A G E N D A
DESIGN REVIEW COMMITTEE

1. CALL TO ORDER
 - a. Introduction of New Member – LJ Gunderson
2. ROLL CALL
3. MINUTES
 - a. December 6, 2012
4. PUBLIC HEARINGS
 - a. Design Review DR13-01 by Michael Barclay, for Barbara A. Bower, to construct a single family dwelling on two platted lots at 2405 Mill Pond Lane within the Gateway Area in the AH-MP, Attached Housing-Mill Pond zone. Staff recommends approval with conditions.
5. COMMUNICATIONS
6. REPORT OF OFFICERS
7. STATUS REPORTS
 - a. Planner Johnson has included status report photographs of the following: DR12-04 for 2042 Marine, DR12-05 for 2042 Marine, and DR12-02 for 2240 Commercial. The projects are complete and conditions have been met. The status reports are for Commission information.
8. OLD BUSINESS
9. NEW BUSINESS
10. ADJOURNMENT

STAFF REPORT AND FINDINGS OF FACT

SUBJECT: Design Review Request (DR13-01) by Michael Barclay for Barbara Bower to construct a single-family dwelling at 2405 Mill Pond Lane

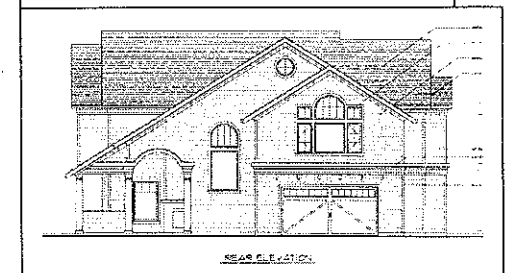
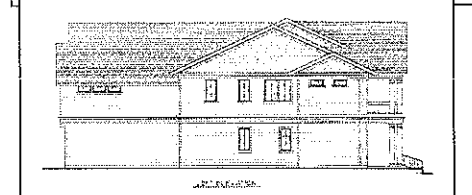
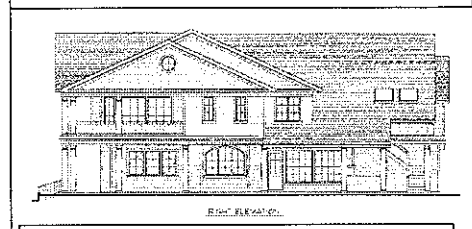
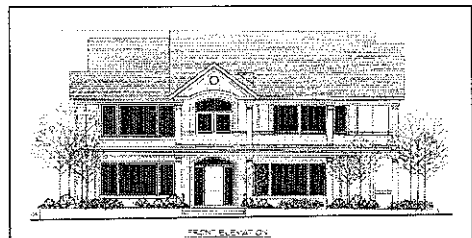
Windows: Mostly vertical, clad wood with external muntins; windows vary on each elevation:

Front: large center picture windows with simulated divided lites above and flanked by simulated eight lite side windows on first and second floor; arched transom with sidelites at main entry door; arched transom above French doors on second story balcony

Right Side: 4x4 multi-lite windows on ground floor; single, paired, and set of three, six lite windows on first and second floors; arched set of three eight lite windows on first floor; round window in gable end

Left Side: single and paired six lite windows on first and second floor; several horizontal windows at eave

Rear: multi-lite Palladian window over garage; arched eight lite over single lite window between the first and second floor; round window in gable end; single window on first floor with simulated divided lites above

FRONT ELEVATION

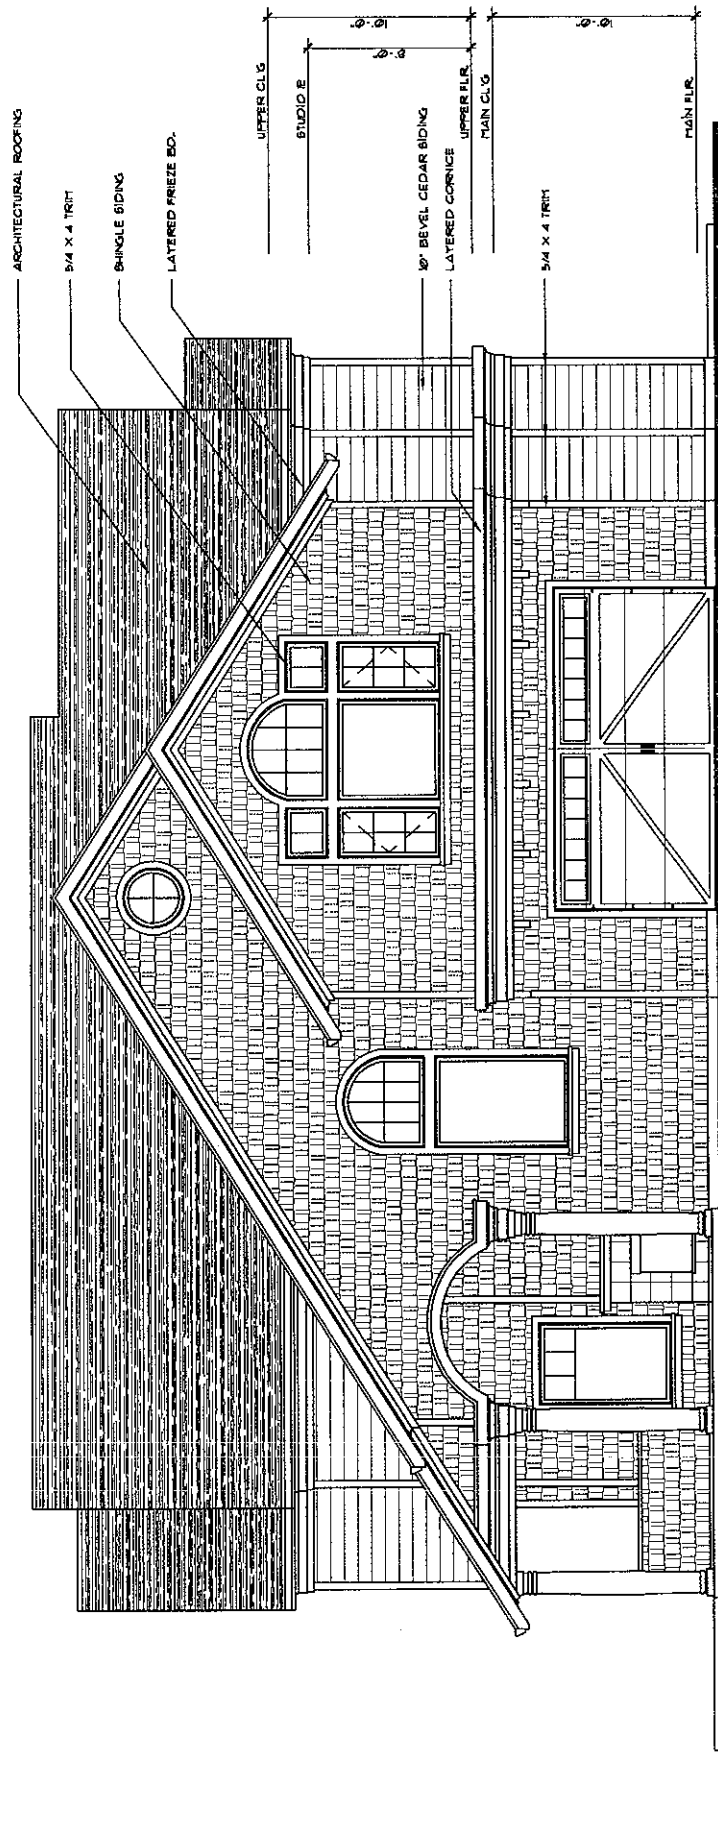
The window divisions are proposed to have exterior muntins. The front elevation has four large areas of windows for approximately 34% of the facade. Window area does not exceed wall area. This guideline is met.
